REMARKS

TI-35949

ANNOTATED SHEET

FIG. 1 (PRIOR ART)

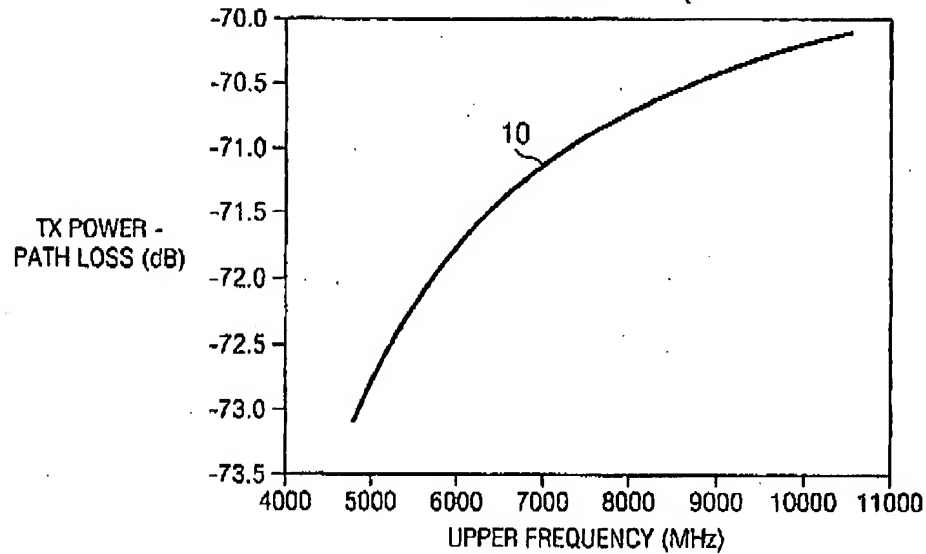
Examiner objects to Figures 1-2 of the drawings as not being designated "Prior Art." Applicants have included a marked up sheet (Annotated Sheet) indicating Figures 1-2 are Prior Art. Applicants have also included a "Replacement Sheet" indicating Figures 1-2 are Prior Art.
